GALLERIA LANDINGS

DEPARTMENT OF SUSTAINABLE DEVELOPMENT - URBAN DESIGN AND PLANNING
DEVELOPMENT REVIEW COMMITTEE SITE PLAN

1180 N. FEDERAL HIGHWAY
FORT LAUDERDALE, FLORIDA

A-110

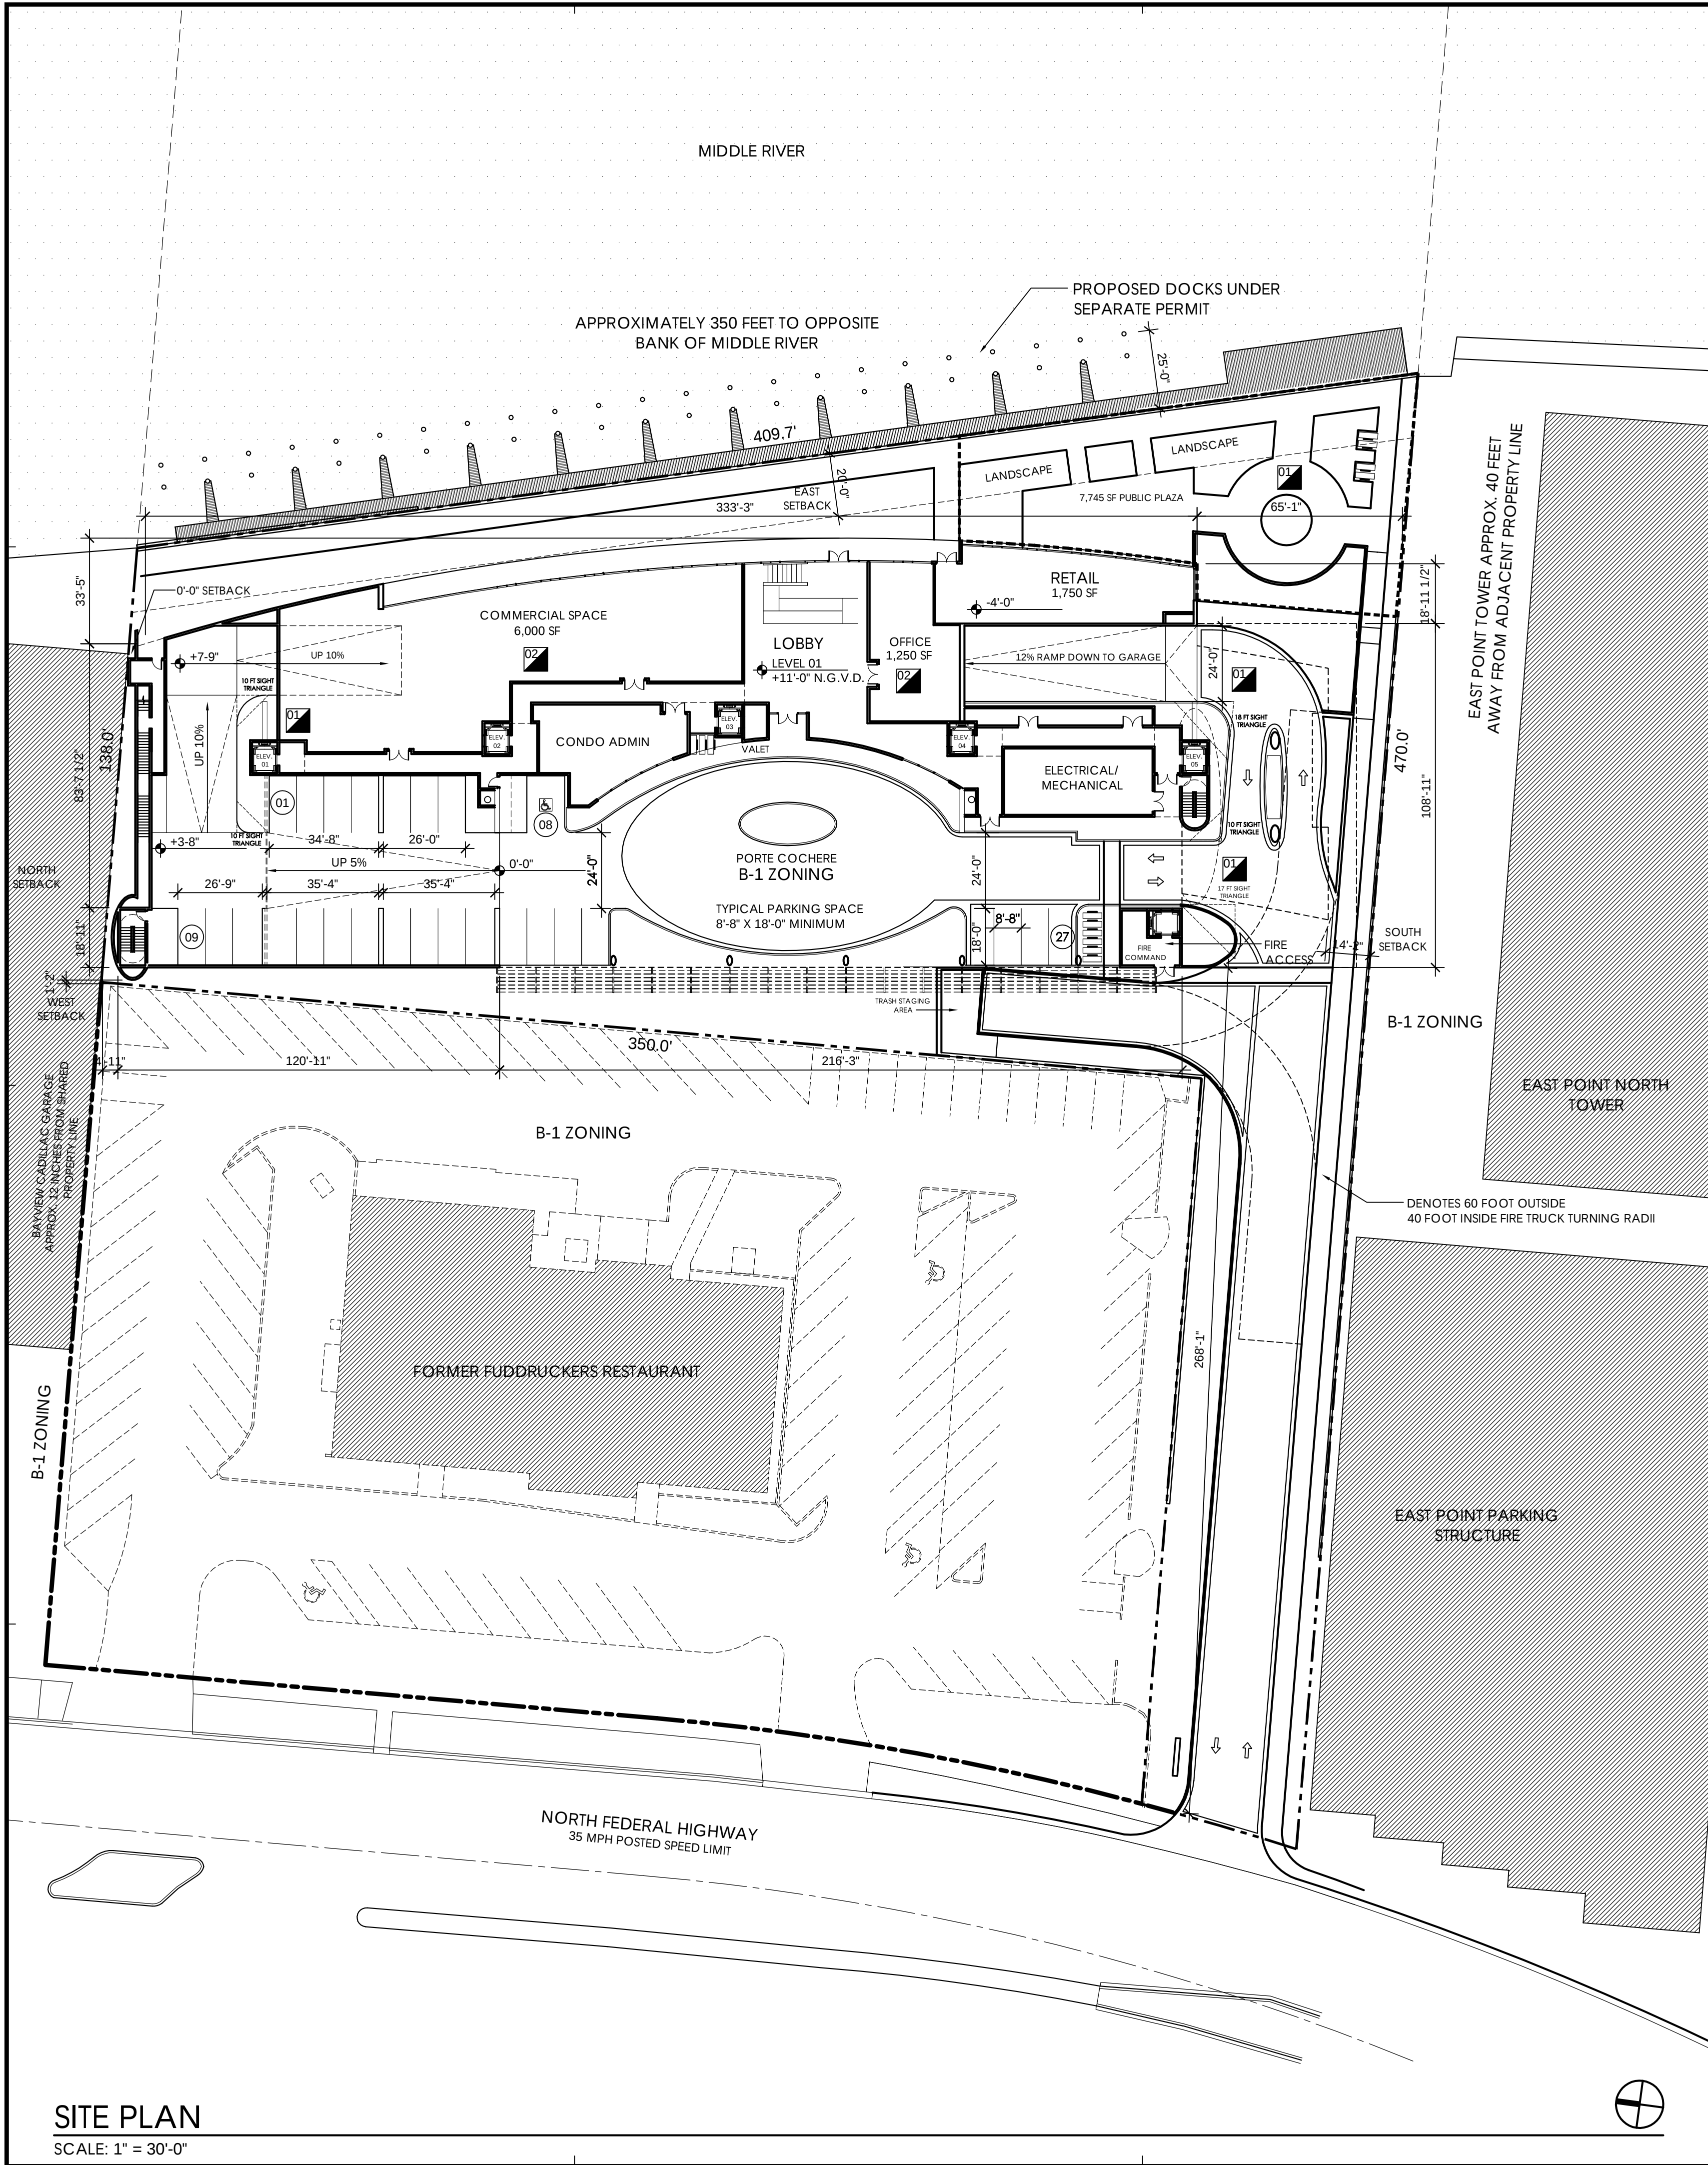
01 DRC COMMENTS
TURN AROUND LABELED
GARAGE REVISION TO EXTEND PUBLIC
PLAZA AREA
COMMERCIAL TRASH STAGING AREA
ADDED
SECURE BIKE STORAGE AREA ADDED
02 DIMENSION CORRECTED

SITE PLAN

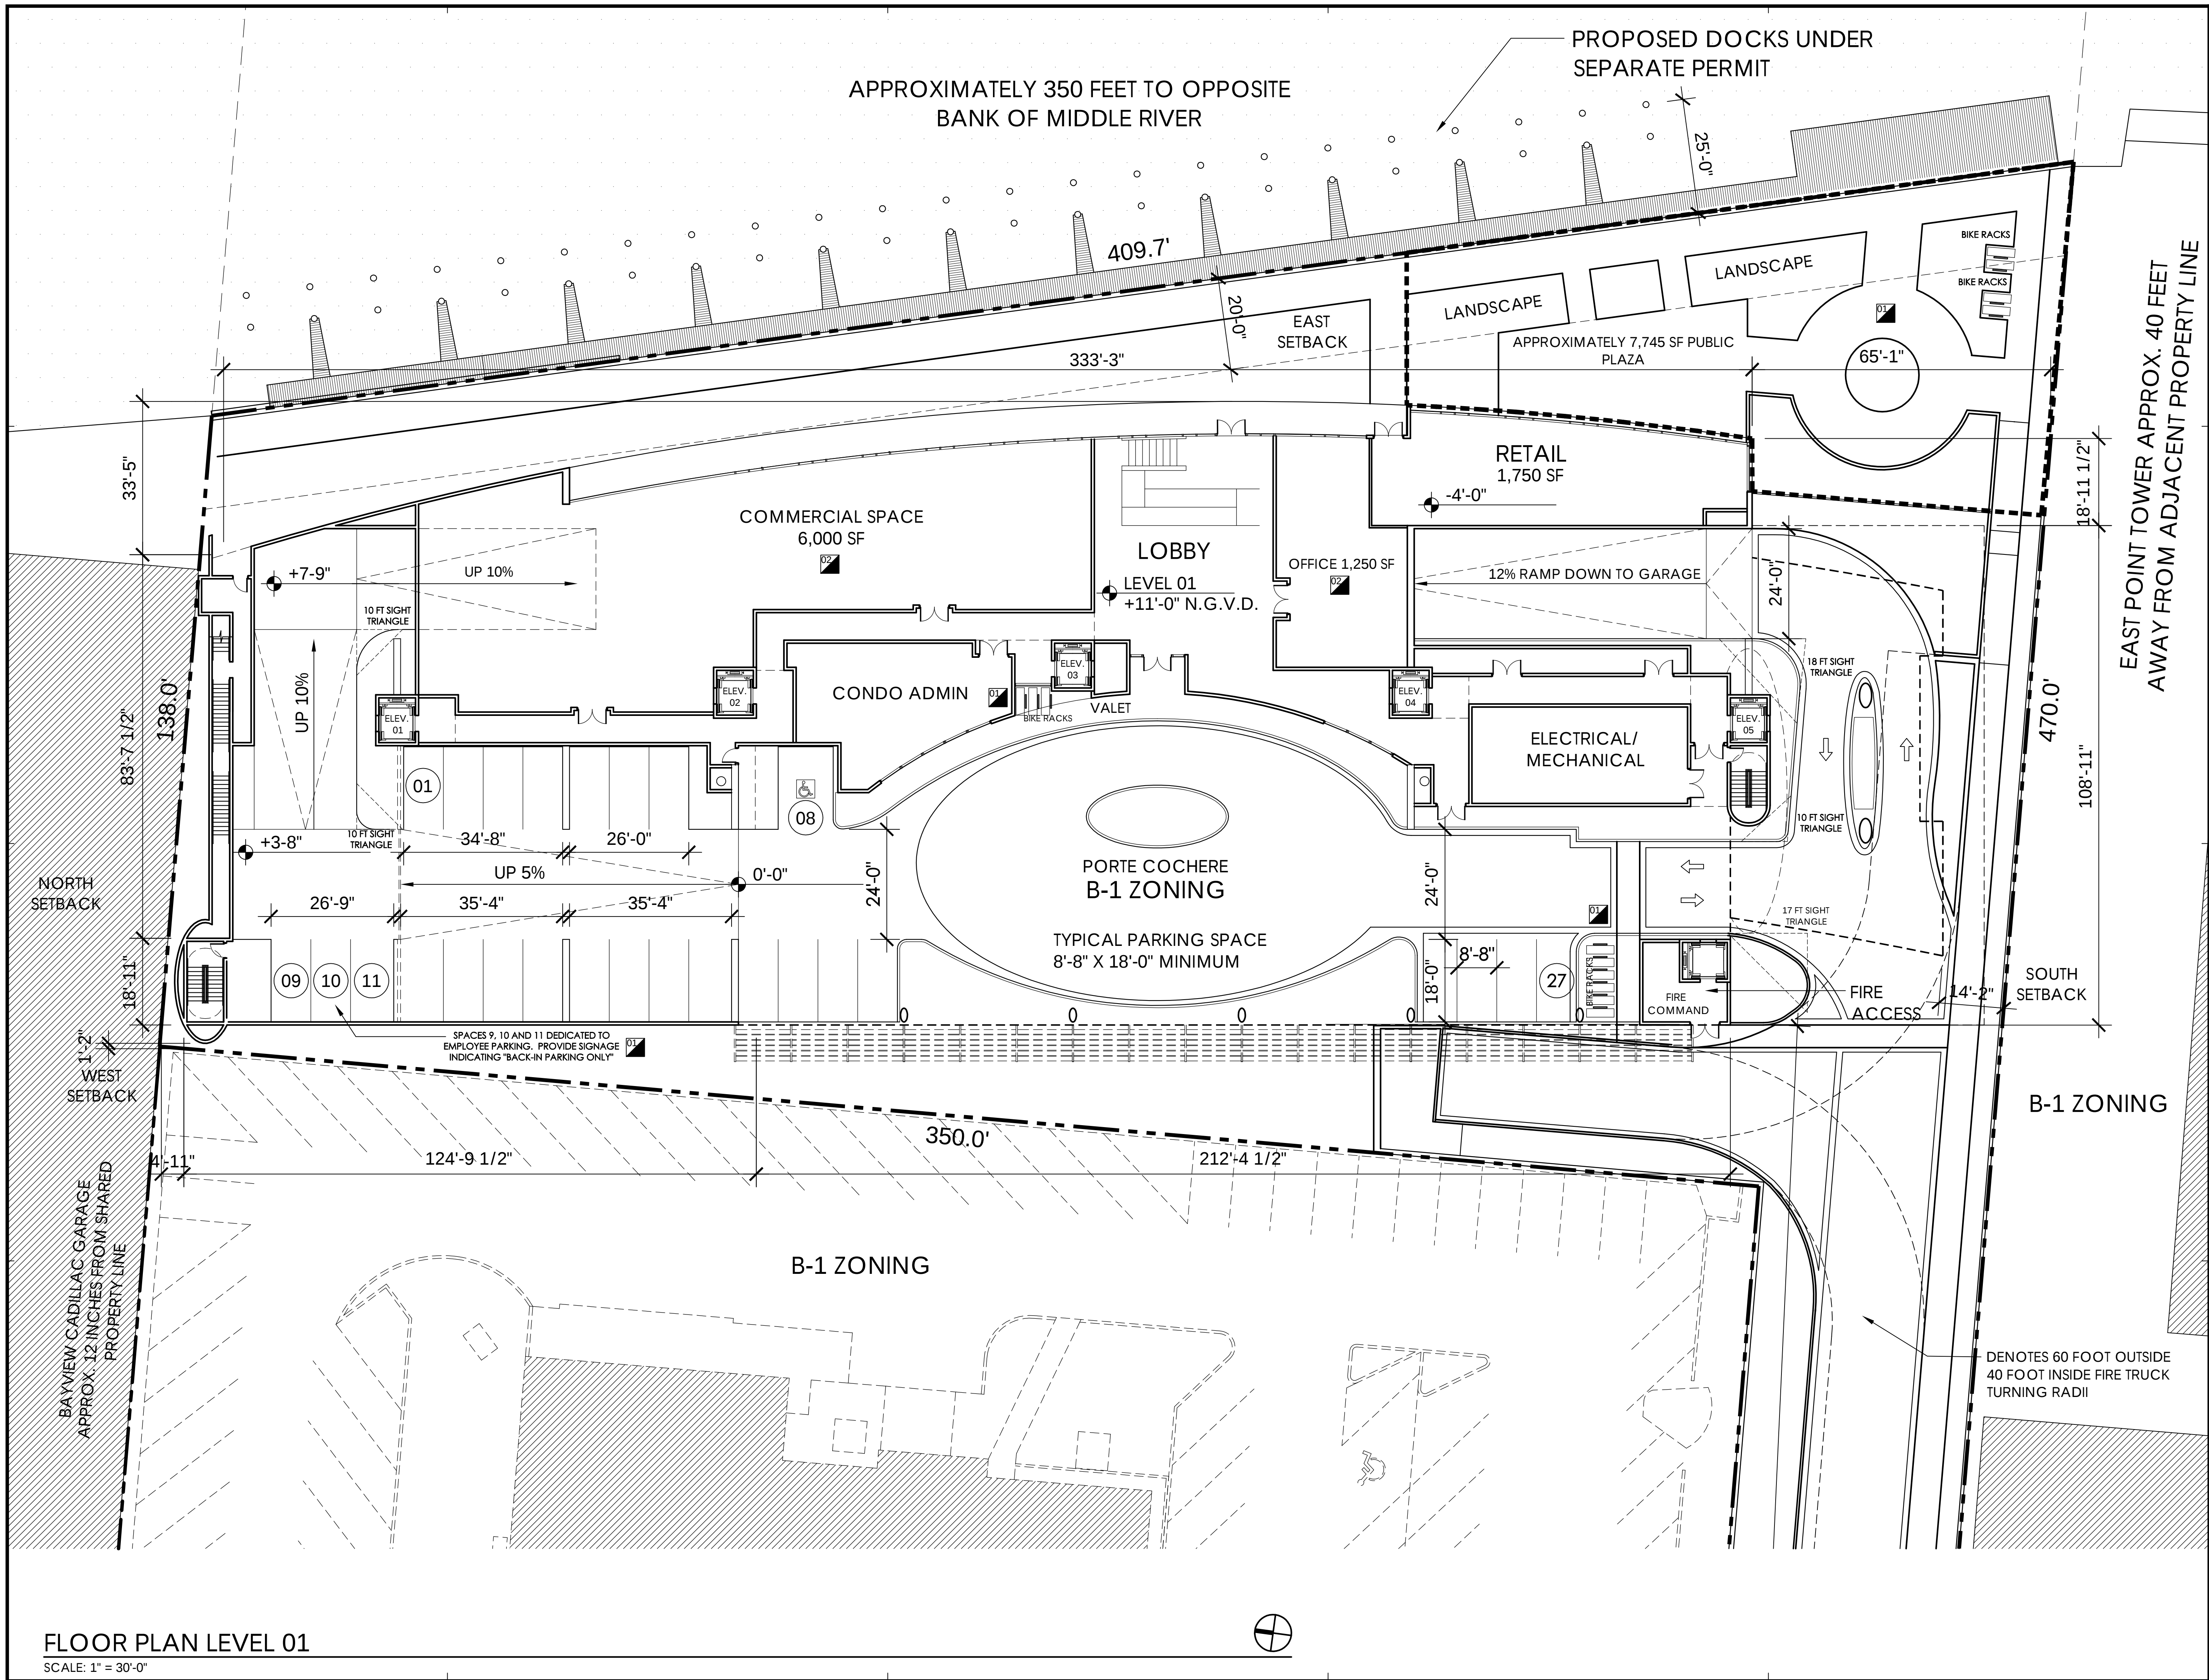
SIGHT TRIANGLE LABELS ADDED

ENTRY DRIVE REVISED TO REMOVE MEDIAN PER FIRE COMMENT

PUBLIC PLAZA RELOCATED AND INCREASED IN SIZE

POLICE NOTES ADDED

[Symbol] RESIDENTIAL UNITS RELOCATED.

COMMERCIAL SPACE RELOCATED TO GROUND LEVEL, RETAIL SPACE INCREASED

FLOOR PLAN LEVEL G1

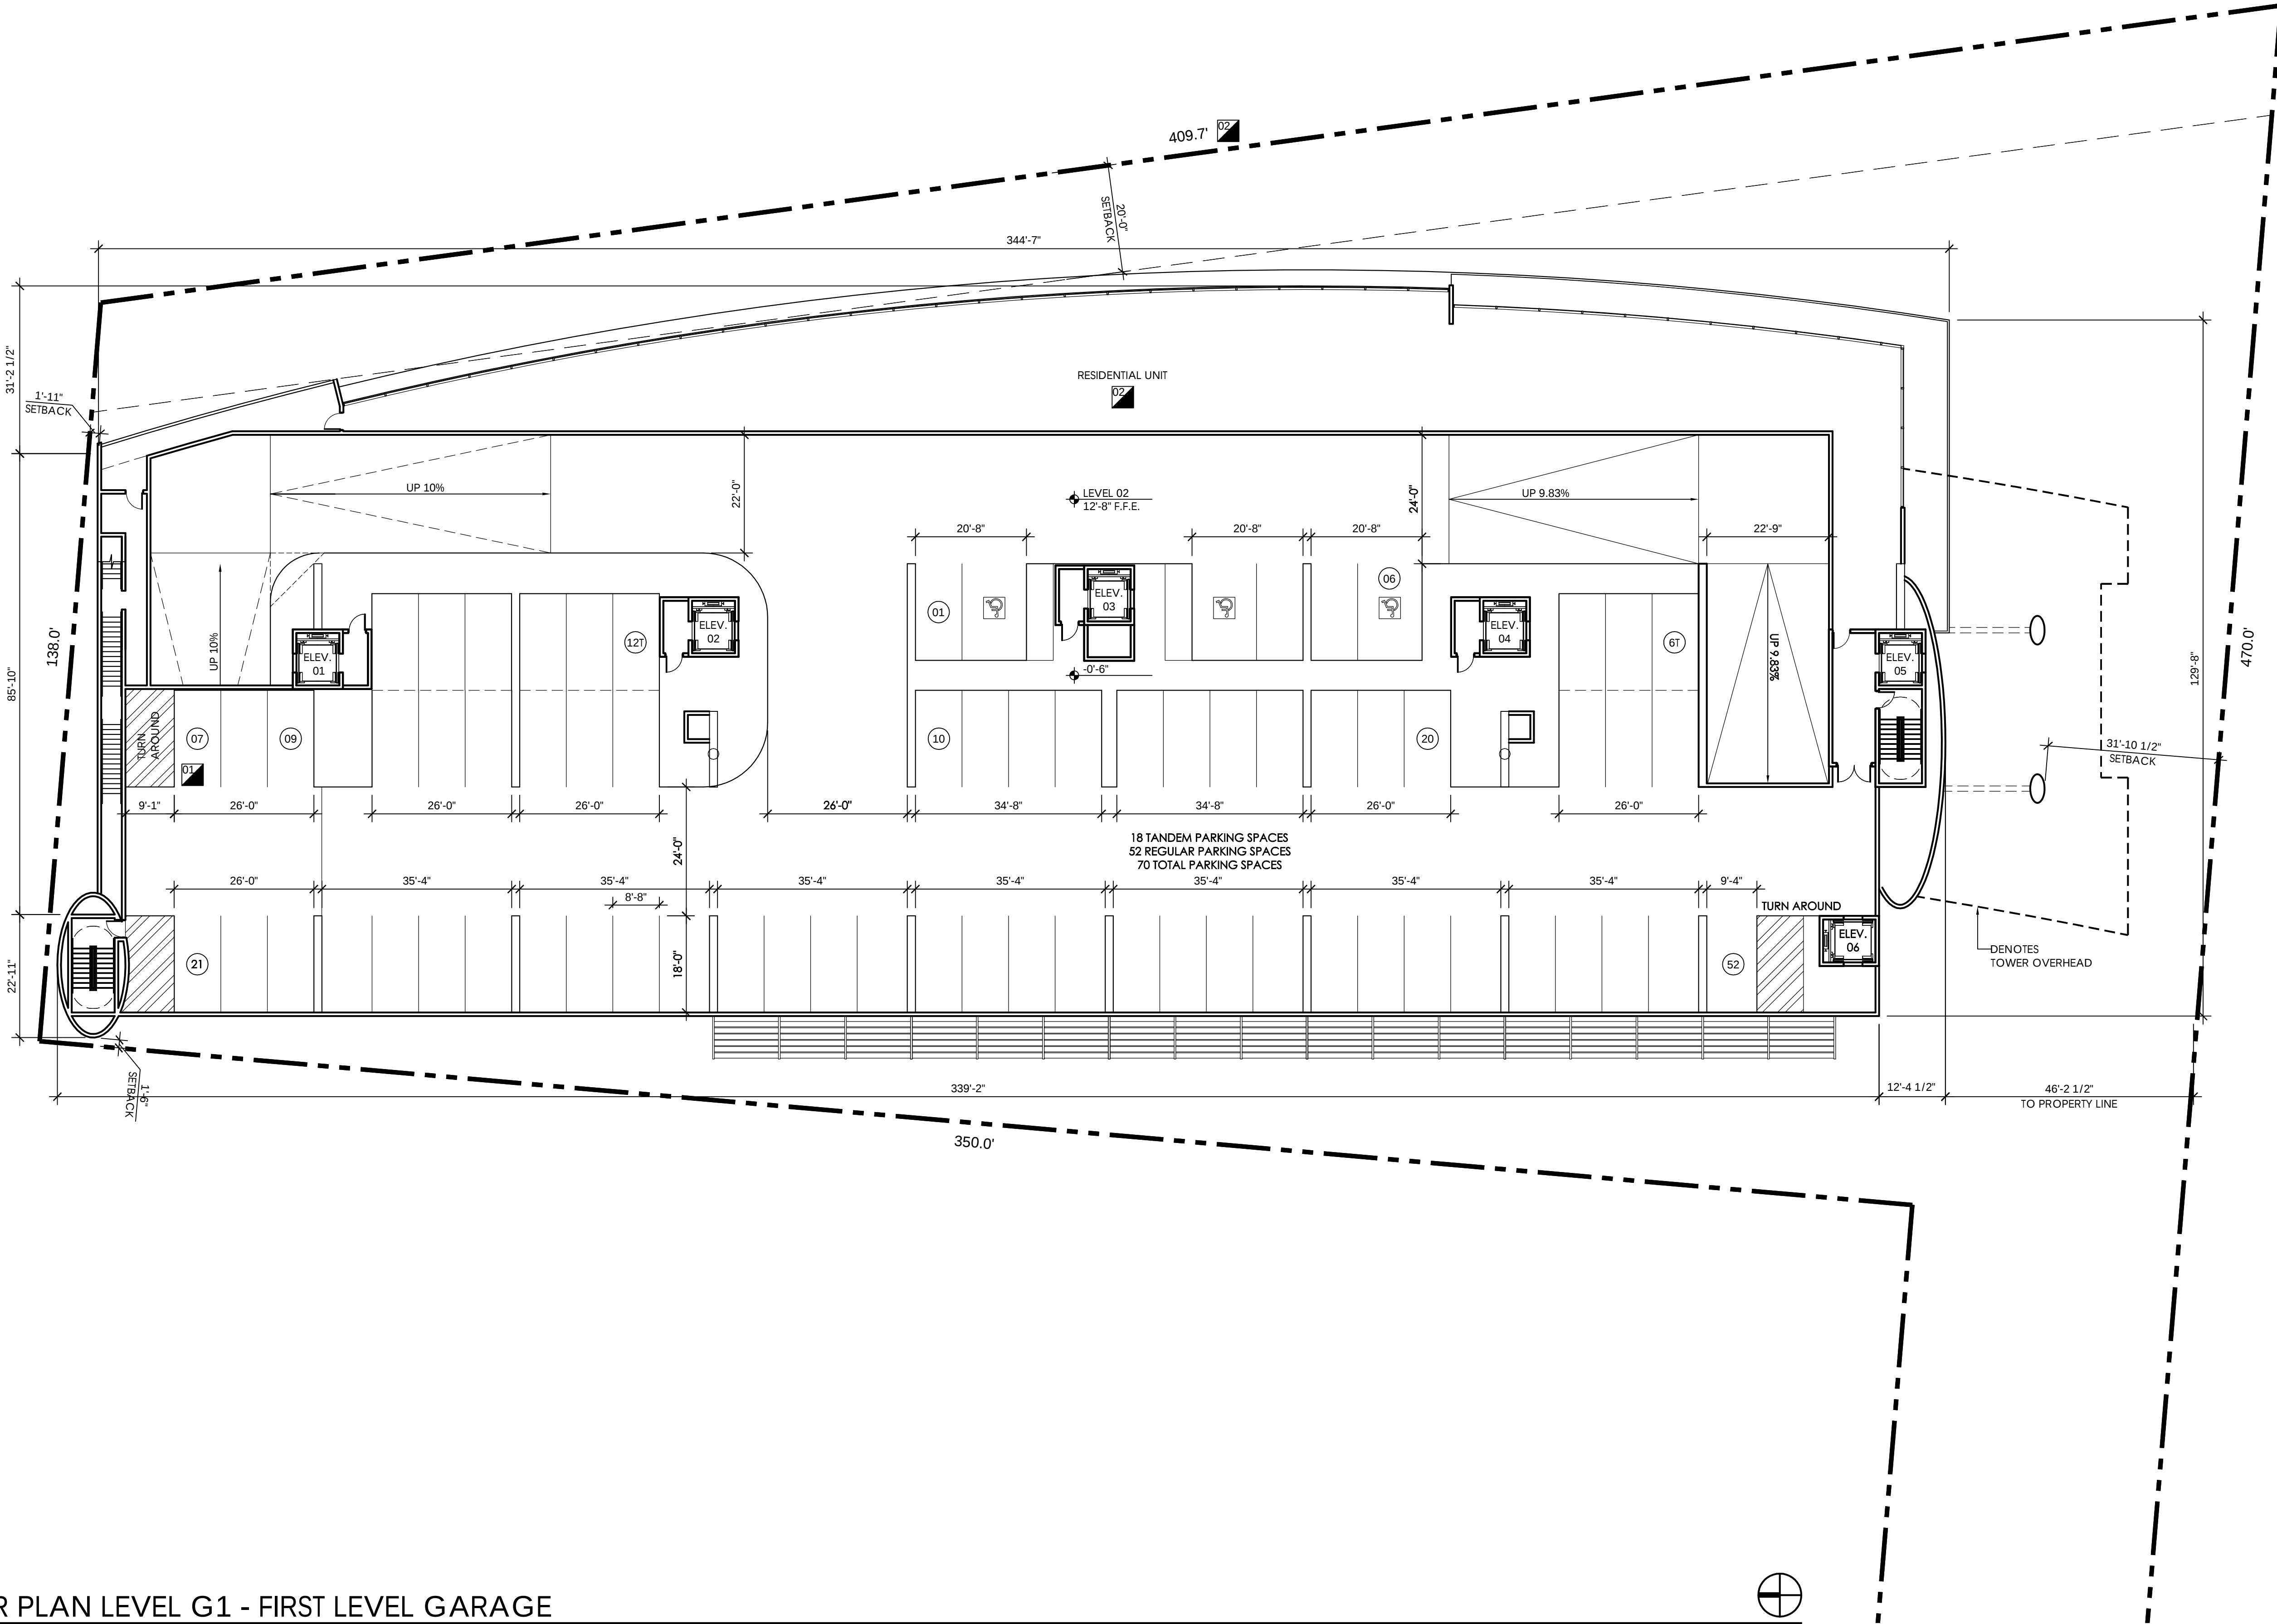
01 DRC COMMENTS
TURN AROUND LABELED
02 COMMERCIAL SPACE REPLACED WITH
RESIDENTIAL UNIT, DIMENSION
CORRECTED.
